**STAFF REPORT**  
**KETCHUM PLANNING AND ZONING COMMISSION**  
**SPECIAL MEETING MARCH 23, 2021**

**PROJECT:** Deep Powder Townhomes Mountain Overlay Design Review and Townhouse Preliminary Plat

**FILE NUMBER:** P21-017 Townhouse Preliminary Plat and P21-018 Mountain Overlay Design Review

**REVIEWER:** Abby Rivin, Senior Planner

DRAWING:  
**A ELEVATIONS**

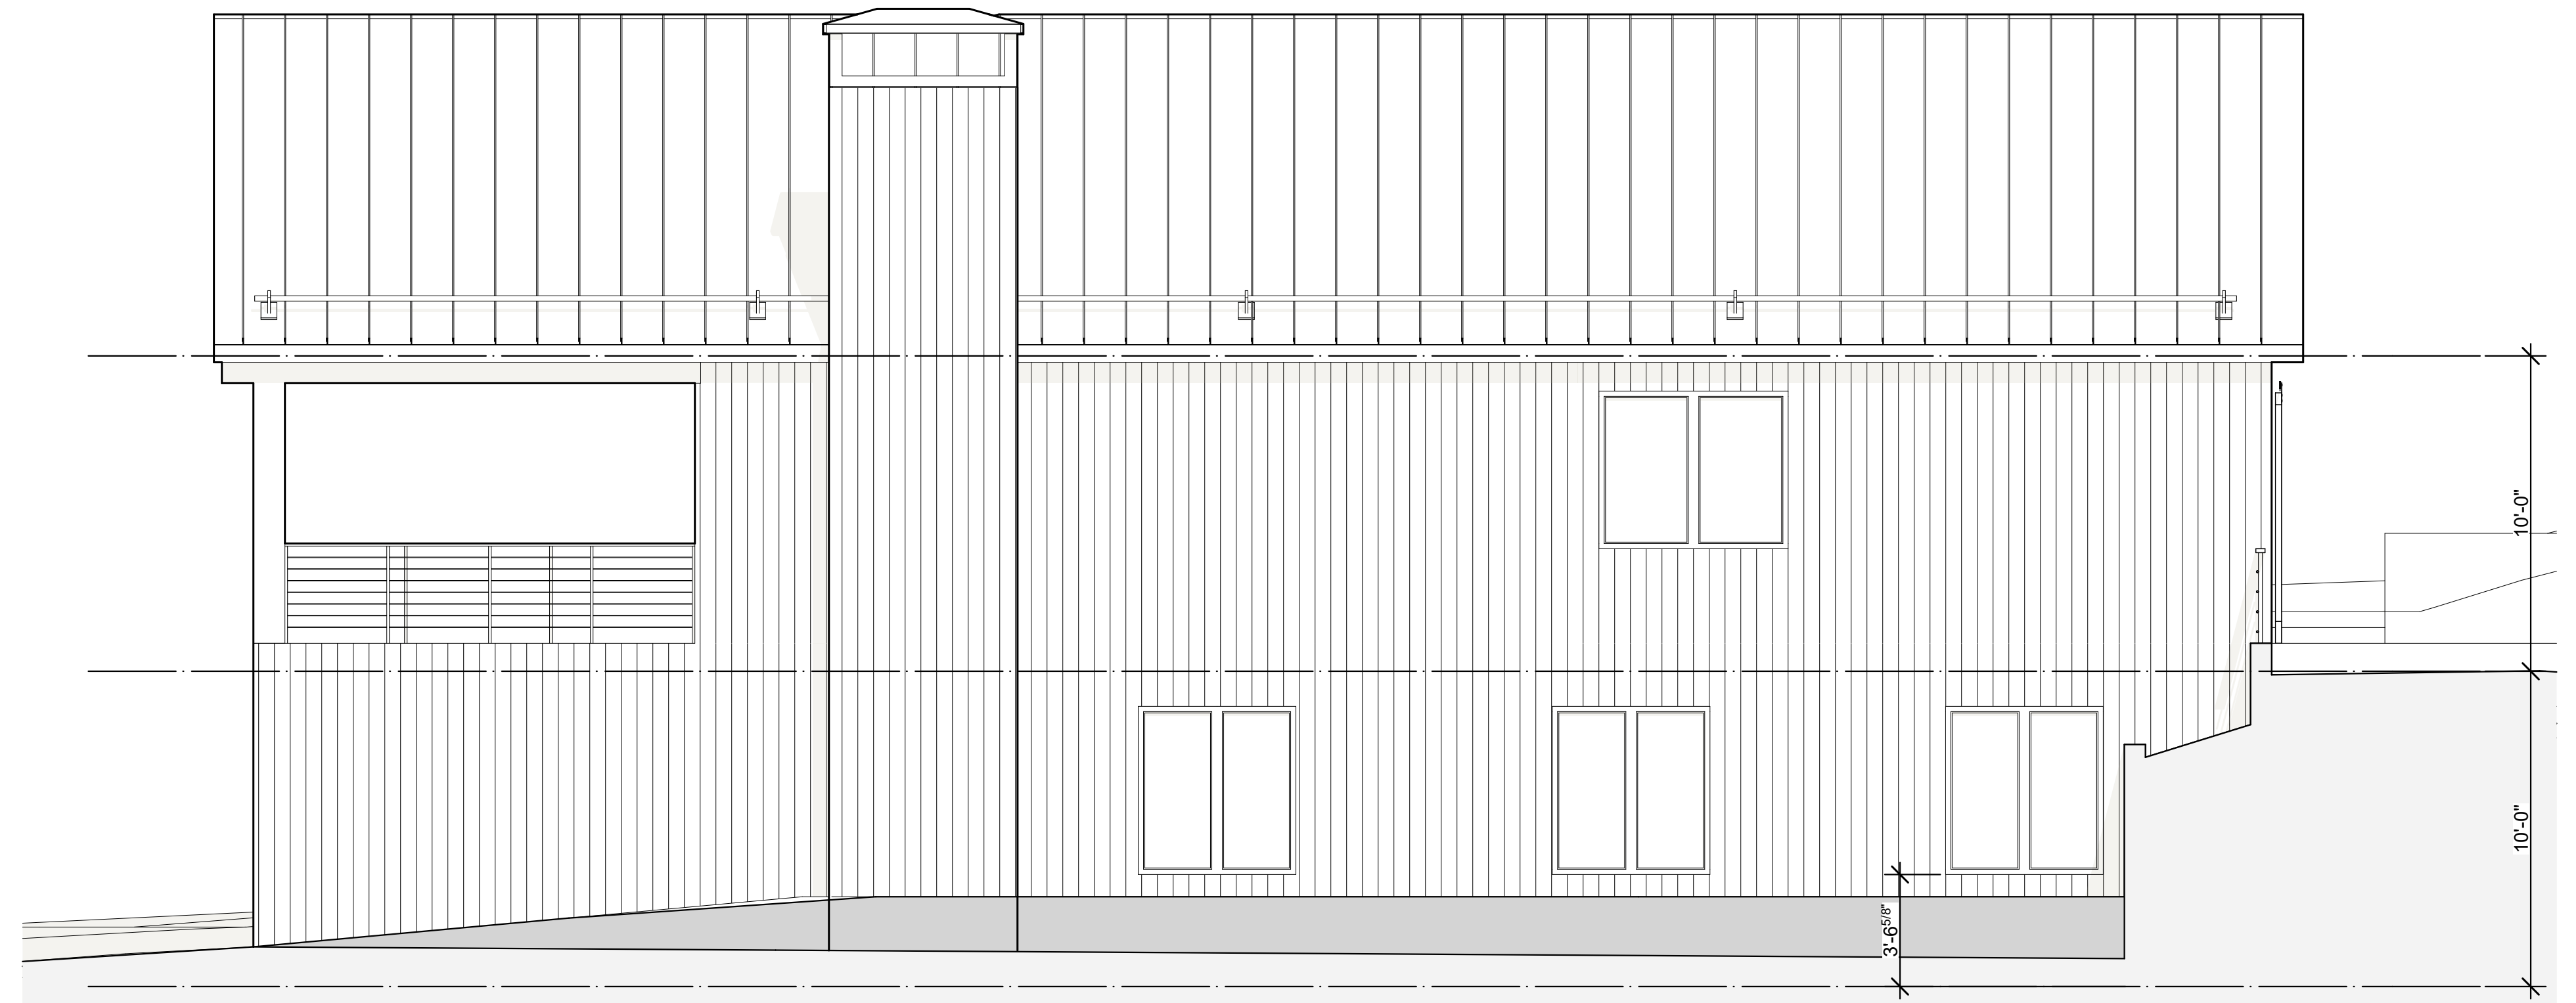
1. All departmental conditions as described in Tables 1, 2, 3, 4, and 5;
2. Limits of disturbance/construction fencing indicated on Sheet L2.0 shall remain in place for the duration of construction;
3. The elevation plans indicate a partial avalanche protection wall on the west side of the western building (Unit A). The design is to be determined. The applicant is aware that the wall cannot exceed 6’ in height and that the wall cannot encroach more than 3’ into the setback that has been established by the building’s height. If final design results in a wall that is greater than 3’ wide the western building’s footprint will be shifted east (toward Unit B) in order to meet the side yard setback requirement.

3. The elevation plans indicate a partial avalanche protection wall on the west side of the western building (Unit A). The design is to be determined. The applicant is aware that the wall can not exceed 6' in height and that the wall can not encroach more than 3' into the setback that has been established by the building's height. If final design results in a wall that is greater than 3' wide the western building's footprint will be shifted east (toward Unit B) in order to meet the side yard setback requirement.

Job No: 19-16  
 Scale: 1" = 10'-0"  
 Issue/Revisions: Date:  
 Design Review 07/03/19  
 All information appearing herein shall not be duplicated, discharged or otherwise used without the written consent of Eggers Associates P.A.  
 Sheet Title:  
 Site Plan  
 Sheet No:  
 L1.0

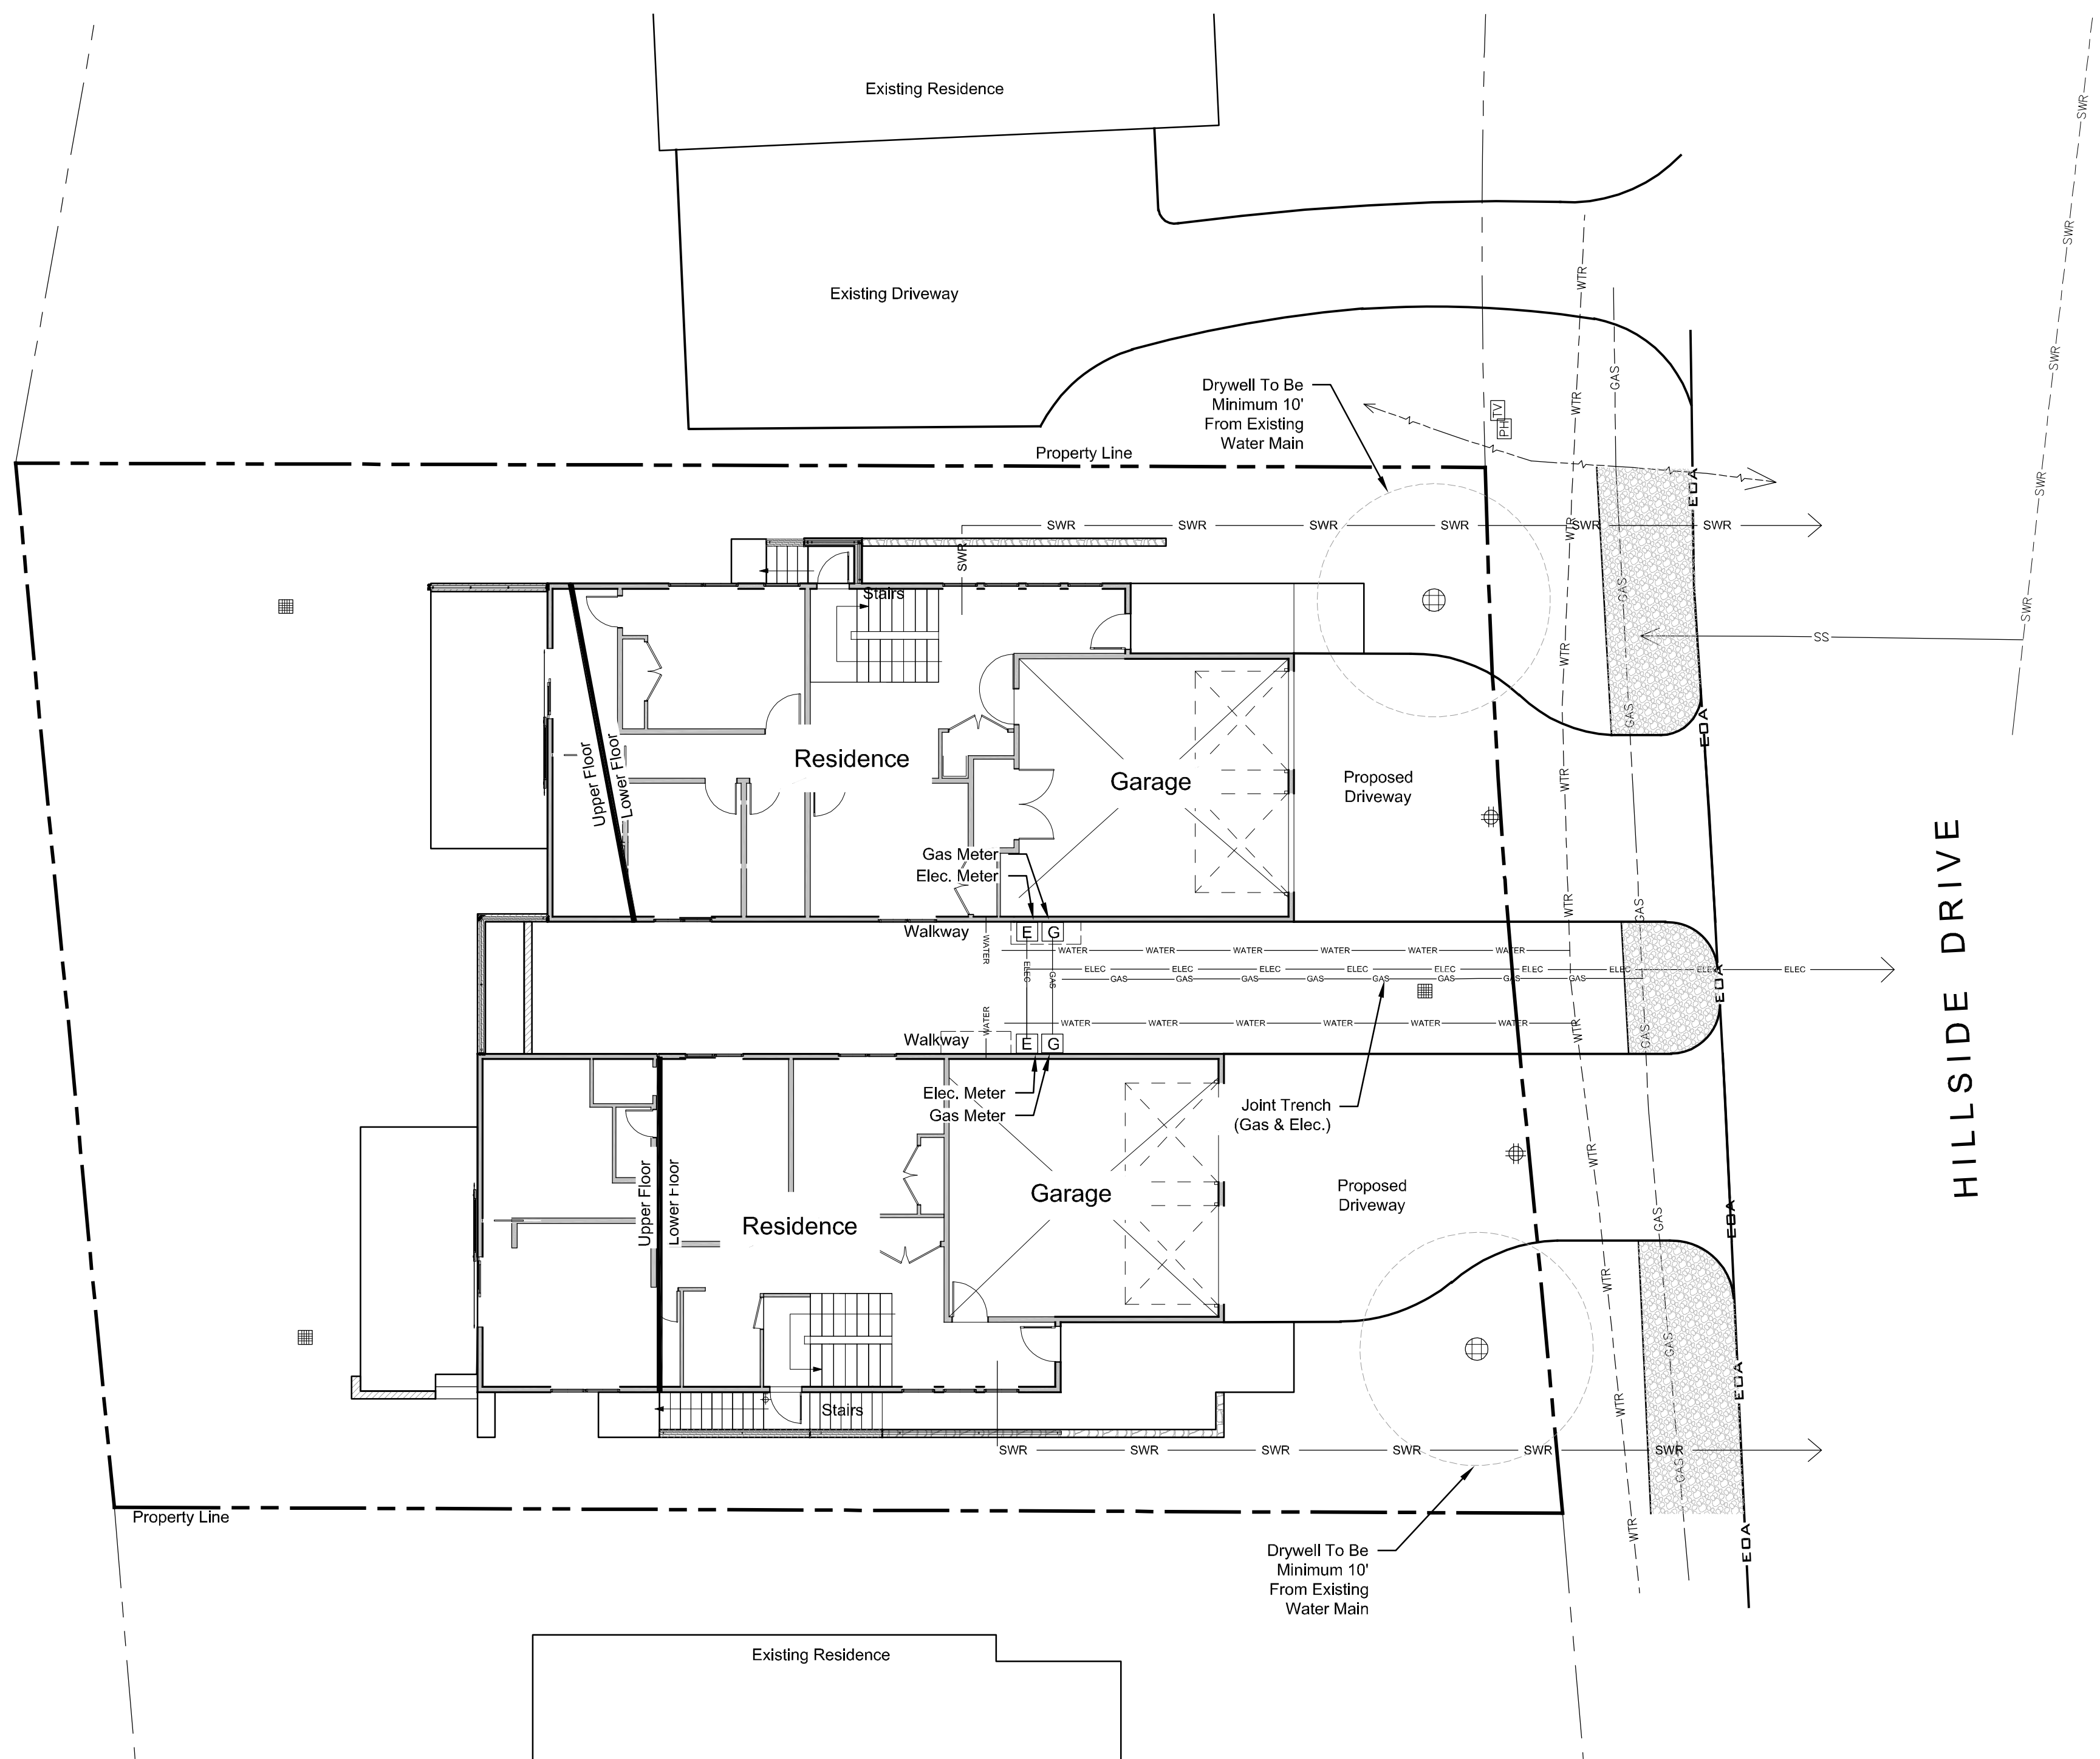
<i>Staff Comments</i>	<i>The applicant proposes to retain all stormwater on site. See sheet L2.0. A final drainage and grading plan will be reviewed and approved by the City Engineer and Streets Department Director through the Building Permit review and approval process.</i>
	<input type="checkbox"/>	<input type="checkbox"/>	17.96.060(C)(2)	<b>Drainage improvements constructed shall be equal to the length of the subject property lines adjacent to any public street or private street.</b>
			<i>Staff Comments</i>	<i>See sheet L2.0.</i>
	<input type="checkbox"/>	<input type="checkbox"/>	17.96.060(C)(3)	<b>The City Engineer may require additional drainage improvements as necessary, depending on the unique characteristics of a site.</b>
			<i>Staff Comments</i>	<i>See City Engineer comments, table 1.</i>
	<input type="checkbox"/>	<input type="checkbox"/>	17.96.060(C)(4)	<b>Drainage facilities shall be constructed per City standards.</b>
